IHKR Blower Resistor Assembly Failure

B 64 05 92 (3503)

SUBJECT: IHKR Blower Resistor Assembly Failure

MODELS: E36 (prior to 9/91 production)

- 1. New Version
- 2. Old Version
- 3. Thermal Switch

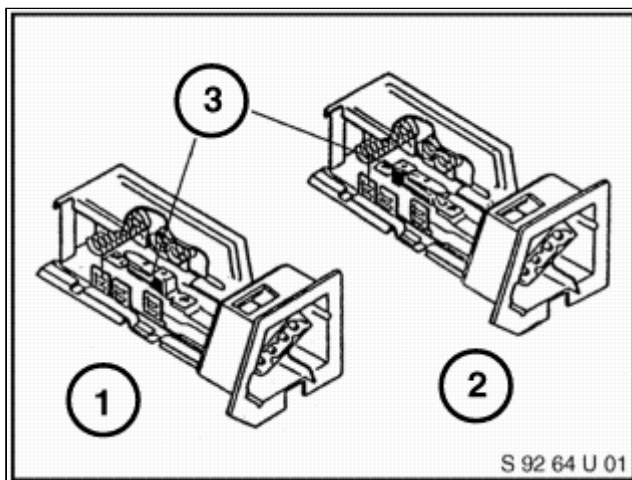
Cause: The support plate of the blower resistor block can heat up, causing an increase in resistance to the thermal switch. As a result, the switch heats up even more and eventually opens. The unit has been redesigned, and orients the thermal switch 180 degrees in position as compared to the older style. Refer to illustration.

Correction: If one of the above complaints is experienced, replace the blower resistor unit.

This shortcoming has been fixed in production for 9/91 and later vehicles. BMW NA will purge its stock of the older units.
